**CITY OF MILL CREEK
DESIGN REVIEW BOARD
APPLICATION PL2019-0010**

NAME OF PROJECT: Creekside Phase II

PROPOSAL: Review of building elevations and landscaping.

SHEET NUMBER
L-1

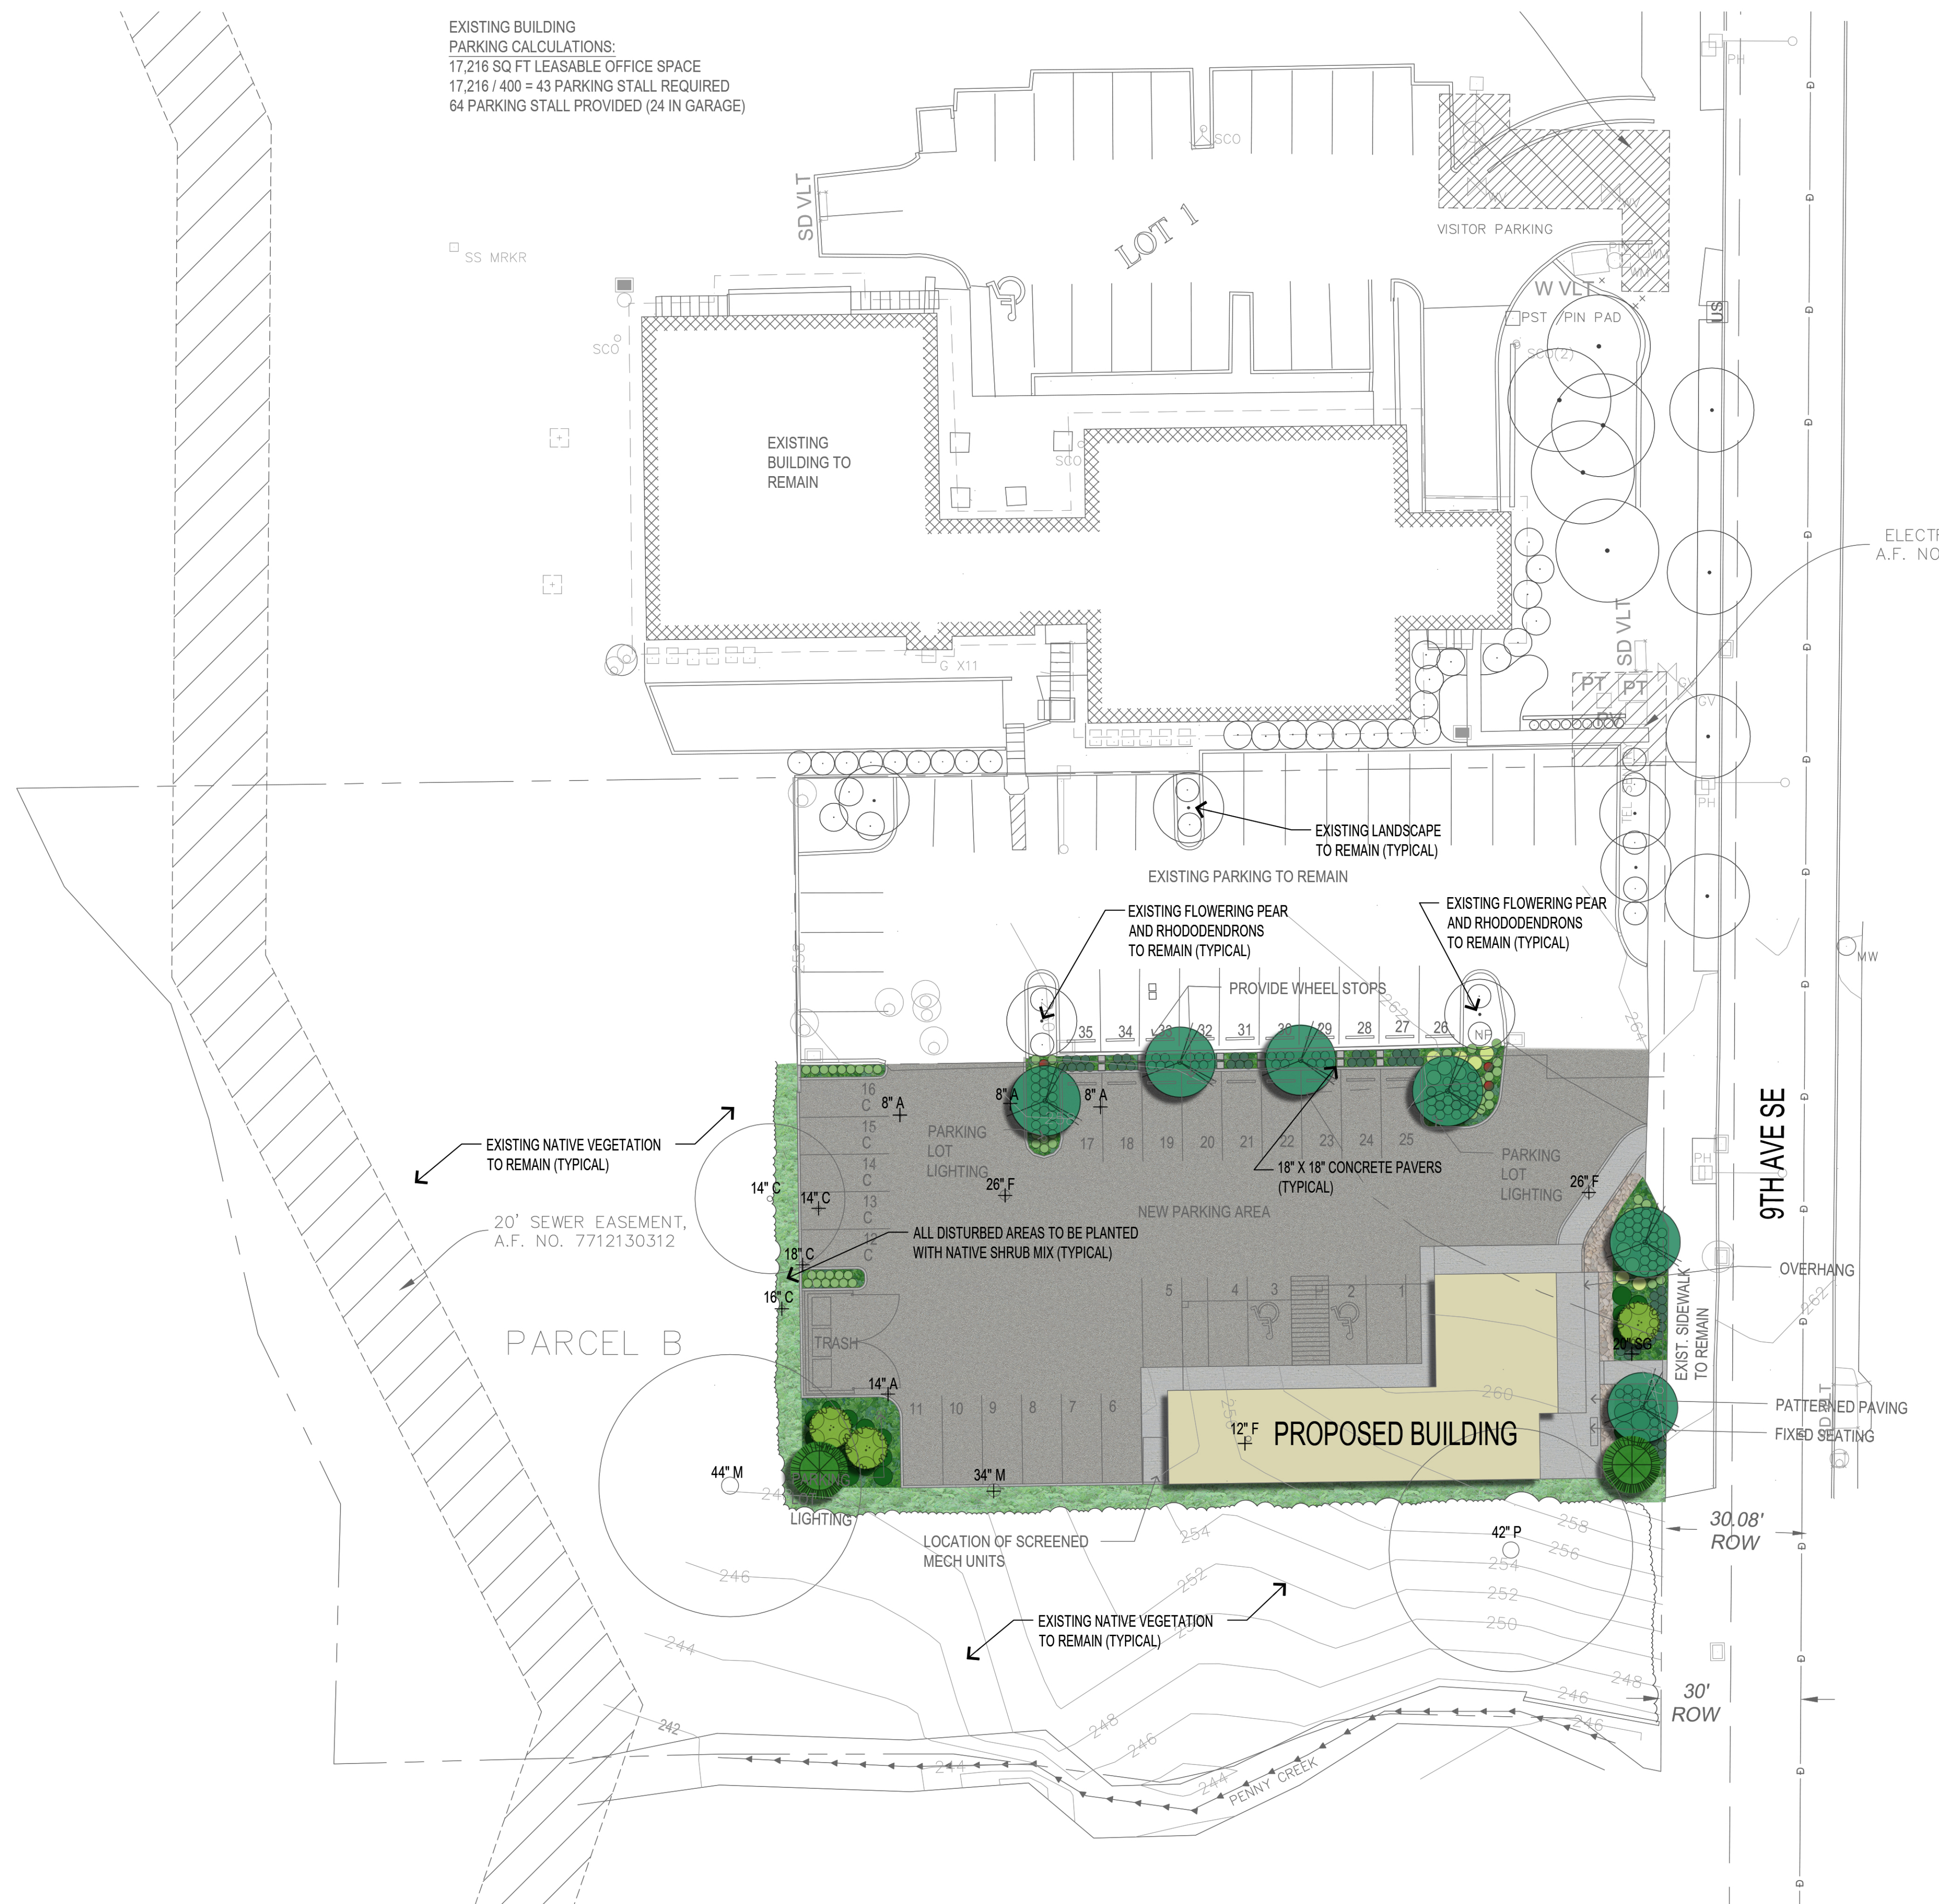
The landscape islands and the landscape bed between the two interior rows of parking is proposed to be planted with Pacific Sunset Maple, shrubs and ornamental grasses. Parking lot lighting will also be located in the landscape islands. Staff has a concern that the Pacific Sunset Maple at a mature height of approximately 30 feet will conflict with the lighting and is recommending the selection of another tree species for the landscape islands.

The landscape bed in the southwest corner is proposed to be planted with an Excelsa cedar, two Vine Maple, shrubs and ground cover (Vinca Minor). The spacing on the Vinca Minor is proposed at 24 inches on center. It is not likely that the requirement for 90 percent coverage in three years can be attained with this spacing; thus, staff is recommending a Condition of Approval that the spacing be 18 inches on center.

The perimeter areas between the parking lot and the critical areas are proposed to be planted with a native shrub mix containing Salal, Oregon Grape, and Snowberry. The spacing on the shrub mix is proposed at 36 inches on center. It is not likely that the requirement for 90 percent coverage in three years can be attained with this spacing; thus, staff is recommending a Condition of Approval that the spacing be 24 inches on center.

- Root barrier is required with all trees within five feet of a paved surface, not just in the parking lot island planters, so it would also be required along the 9th Avenue Southeast frontage.

- The Mill Creek Planting Standards should be included on the plans.
- The original Binding Site Plan approval included a Condition of Approval that, “A 42-inch solid fence or wall be installed along the western edge of the parking lot to minimize lighting impacts from vehicles on wildlife habitat within the adjacent wetlands.” The fence or wall should be shown on the landscape plan.

- The Code states that, “Where parking lot design results in head-in parking adjacent to landscape areas, the landscape areas shall be protected by wheel stops or another method adequate to prevent damage by overhanging vehicles.” The plan should show wheel stops in the spaces adjacent to the perimeter landscape beds as well as the interior landscape bed.

- Provide landscaping (either shrubs or groundcover or a combination) in the landscape bed in the sidewalk on 9th Avenue Southeast.
- Place a couple of planter pots by the front entry doors.

2. Modify the landscape plan as follows:
 - Adjust the spacing on the Native Shrub Mix to 24 inches on center;
 - Adjust the spacing on the Vinca Minor to 18 inches on center;

- Show root barrier adjacent to the parking lot trees and the trees along the sidewalk on 9th Avenue Southeast;
 - Show wheel stops on all parking spaces;

- Show the fence/wall along the western edge of the parking lot and provide a detail of materials and colors;
 - Propose an alternate tree species for the two landscape islands by the interior parking spaces to avoid a conflict with the parking lot lighting; and

- Landscape the small bed in the sidewalk along 9th Avenue SE with either shrubs or groundcover or a combination.
 - Add planter pots by the front entry.
